UNITED STATES PATENT AND TRADEMARK OFFICE

APPLICATION NO.	FILING DATE	FIRST NAMED INVENTOR	ATTORNEY DOCKET NO.	CONFIRMATION NO.
09/455,991	12/06/1999	HISASHI OHTANI	07977/213002	5835

Office Action Summary	Application No.	Applicant(s)	
	09/455,991	OHTANI ET AL.	
	Examiner	Art Unit	
	José R Díaz	2815

DETAILED ACTION

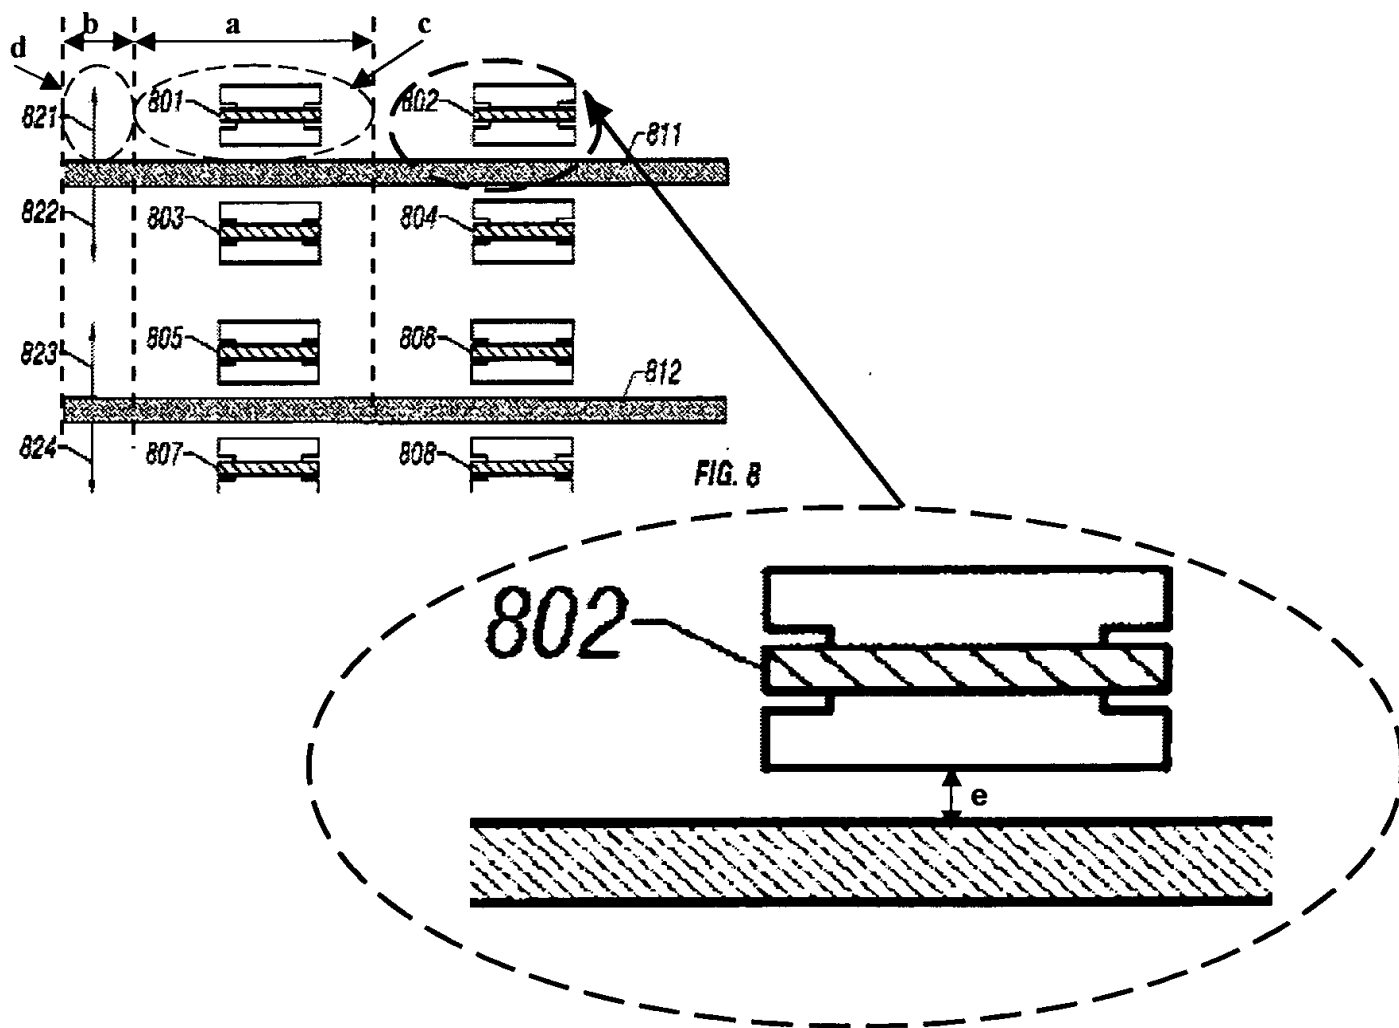
Regarding claim 6, Applicant acknowledges that is well known in the art a method comprising the steps of: forming an amorphous semiconductor film on an insulator surface (see "Description of the Related Art" and Figs. 1B and 8); providing a metal element (811, 812) capable of promoting crystallization of the amorphous

semiconductor film to form a first metal element added region (a) and a second metal element added region (b) (see Fig. 8, attached hereto); crystallizing the amorphous semiconductor film so that a crystal growth (821, 822, 823, 824) proceeds in a crystal growth direction parallel to the insulating surface to form first and second crystalline portion (c, d) (see Fig. 8, attached hereto); patterning the crystalline semiconductor film to form at least one crystalline island (801) using only the first crystalline portion (c) (see Fig. 8, attached hereto); wherein carrier move in the crystalline semiconductor island (801) in a carrier moving direction identical with the crystal growth direction (821) (see "Description of the Related Art" and Fig. 8); wherein the second metal element added region (b) is located apart from the crystalline semiconductor island (801) by a distance (e) (see Fig. 8, attached hereto); wherein the first metal element added region (a) has a length extending longer from an end portion of the crystalline semiconductor island (801) in a longitudinal direction of the first metal element added region (consider the portion of the metal element (811) that is between the end side of the region (b) and the end side of the crystalline semiconductor island (801)) (see Fig. 8, attached hereto).

Regarding claims 7, 32 and 56, Applicant acknowledges that the lengths of the first metal element added region (a) and the second element added region (b) are set to 50% or more of a crystal growth distance (e) (Compare the length of the distance (e) with the lengths of each region (a, b)).

Regarding claims 8, 25, 33, 41, 49, 57 and 65, Applicant acknowledges that the metal element comprises at least Ni (811) (see Fig. 8 and page 3, line 21 of Applicant's Specification).

Regarding claims 24 and 48, Applicant acknowledges that is well known in the art a method comprising the steps of: forming an amorphous semiconductor film on an insulator surface (see "Description of the Related Art" and Figs. 1B and 8); providing a metal element (811, 812) capable of promoting crystallization of the amorphous semiconductor film (see Fig. 8, attached hereto); crystallizing the amorphous semiconductor film so that a crystal growth (821, 822, 823, 824) proceeds in a crystal growth direction parallel to the insulating surface from a metal element added region (811, 812) (see Fig. 8, attached hereto); patterning the crystalline semiconductor film to form at least one crystalline island (801) (see Fig. 8, attached hereto); wherein the metal element added region (811, 812) has a length extending longer from an end portion of the crystalline semiconductor island (801) in a longitudinal direction of the metal element added region (811) (see Fig. 8, attached hereto).

Regarding claims 31, 39, 55 and 63, Applicant acknowledges that is well known in the art a method comprising the steps of: forming an amorphous semiconductor film on an insulator surface (see "Description of the Related Art" and Figs. 1B and 8); providing a metal element (811, 812) capable of promoting crystallization of the amorphous semiconductor film to at least two selected regions (c, d) of the amorphous semiconductor film (see Fig. 8, attached hereto); crystallizing the amorphous

semiconductor film so that a crystal growth (821, 822, 823, 824) proceeds in a crystal growth direction parallel to the insulating surface (see Fig. 8, attached hereto); patterning the crystalline semiconductor film to form at least one crystalline island (801) (see Fig. 8, attached hereto); wherein a portion (d) of the crystalline semiconductor film formed by using one metal element added region (811) is not used to form crystalline semiconductor islands (801) (see Fig. 8, attached hereto).

Regarding claims 40, 47, 64 and 71, Applicant acknowledges that is well known in the art a method comprising the steps of: forming an amorphous semiconductor film on an insulator surface (see "Description of the Related Art" and Figs. 1B and 8); providing a metal element (811, 812) capable of promoting crystallization of the amorphous semiconductor film to at least two selected regions (c, d) of the amorphous semiconductor film (see Fig. 8, attached hereto); crystallizing the amorphous semiconductor film so that a crystal growth (821, 822, 823, 824) proceeds in a crystal growth direction parallel to the insulating surface (see Fig. 8, attached hereto); patterning the crystalline semiconductor film to form at least one crystalline island (801) (see Fig. 8, attached hereto); wherein the metal element added region (811, 812) has a length extending longer from an end portion of the crystalline semiconductor island (801) in a longitudinal direction of the metal element added region (811) (see Fig. 8, attached hereto); and wherein a portion (d) of the crystalline semiconductor film formed by using one metal element added region (811) is not used to form crystalline semiconductor islands (801) (see Fig. 8, attached hereto).
